## Historic Review

### Staff Report and Notice of Decision for a Mixed Use Building in the McLoughlin Conservation District February 27, 2020

**FILE NO.:** GLUA-20-00006 and HR 20-02: Historic Review for a new two-story mixed use building in the McLoughlin Conservation District.

**REQUEST:** A new two-story mixed use building in the McLoughlin Conservation District.

Streetscape Illustration

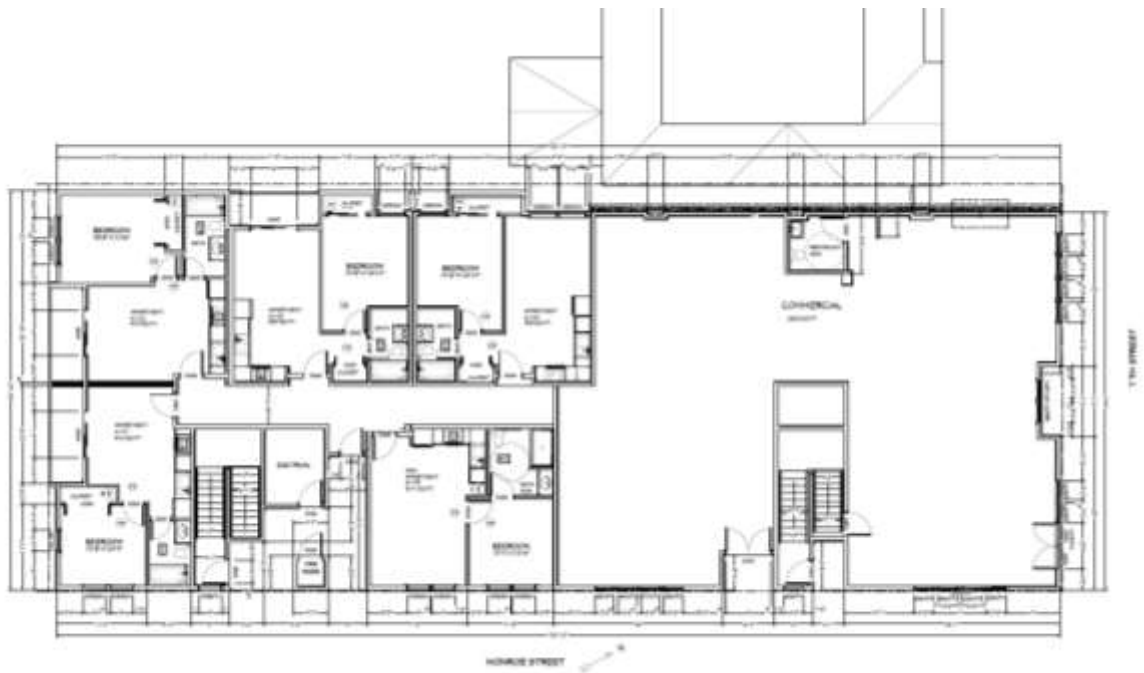
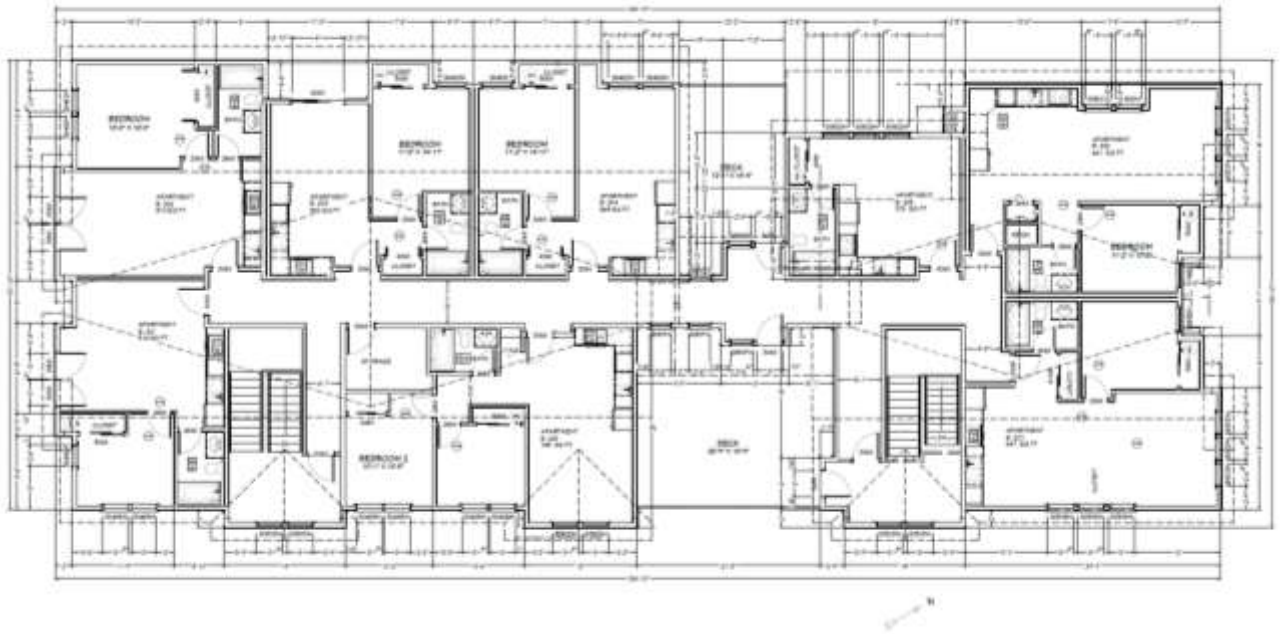
The structure is proposed to be set back approximately 3 feet from the side property line shared with the Church House to leave a minimum separation between the buildings to meet fire codes. It appears that the Church House has a zero-foot setback, or perhaps a very small setback from the property line. The structure will project closer to the street than the Church building, and will obscure the side view of the historic structure. In order to reduce the impact on the Church building, the applicant shall ensure that the new structure walls are placed at least five feet from the Church building eave, or to meet minimum building code requirements, whichever is greater.

The applicant has proposed an 11 foot floor to ceiling height for the ground floor commercial space; while the guidelines call for 12 foot minimum unless for multifamily use. About half of the ground floor is proposed to be residential, and the front half is proposed as commercial space. The second floor height appears to be 8 feet. The applicant shall revise the floor heights to meet the guidelines as at least 12 feet for commercial areas, and at least 10 feet for residential areas.

The proposed 8:12 roof pitch meets the guidelines for Vernacular, but is too shallow for a Queen Anne style.

The applicant proposed a 50-foot wide building with ground floor windows along 60% of the front façade. The storefront windows include a transom above and a short bulkhead wall.

The elevations show a brick veneer façade about halfway up the first story, with lath and plaster on the second half. The second story is proposed with fiber cement board siding with 5" reveal, and cedar shingles at gables. The applicant shall ensure that shakes/shingles are straight across and not jagged.

1. The applicant shall revise the floor heights to meet the guidelines to at least 11 feet for commercial areas, and at least 10 feet for residential areas.
2. The applicant shall ensure that the new structure walls are placed at least five feet from the Church building eave, or to meet minimum building code requirements, whichever is greater.
3. Minor changes to window placement or location on side and rear facades are permitted without additional HRB review.

4. The window sash shall be the darkest color of the paint scheme.
5. The applicant shall use historically appropriate decorative lighting with medium to warm color. All signs shall be externally lit.
6. The horizontal fiber cement board siding shall be smooth.
7. The applicant shall ensure that shakes/shingles are straight across and not jagged.
8. Balcony railing material shall be wood with top and bottom rail, and balusters interior to the rail.
9. Aluminum doors shall be finished; no bare aluminum is allowed.
10. The awning shall be no steeper than 45 degrees from horizontal. No shiny or coated awnings are allowed. (P)
